Airworthiness Directive Schedule

Piper PA-24 Series (Comanche)

28 June 2018

Figure 1

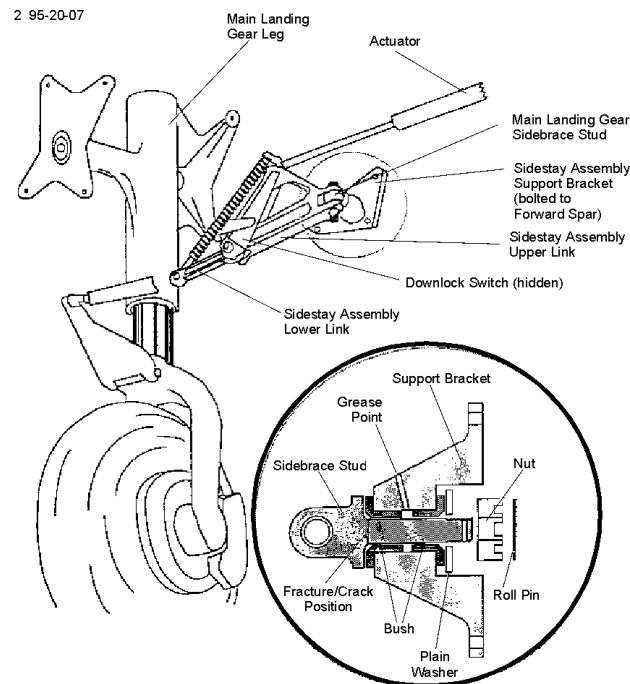
Remove both the left and right main gear sidebrace studs from the aircraft per the instructions in the landing gear section of the aircraft MM. Inspect both the main gear sidebrace stud for cracks using Type I (fluorescent) liquid penetrant or magnetic particle inspection methods. Figure 1 of this AD depicts the area where the sidebrace stud is to be inspected.

For any main gear sidebrace stud not found cracked, before to further flight reinstall the stud per the instructions in the Landing Gear section of the applicable MM, and reinspect and replace (as necessary) per this AD.

For any main gear sidebrace stud found cracked, before to further flight replace the cracked stud with a serviceable part per the instructions in the Landing Gear section of the applicable MM, and reinspect and replace (as necessary) per this AD.
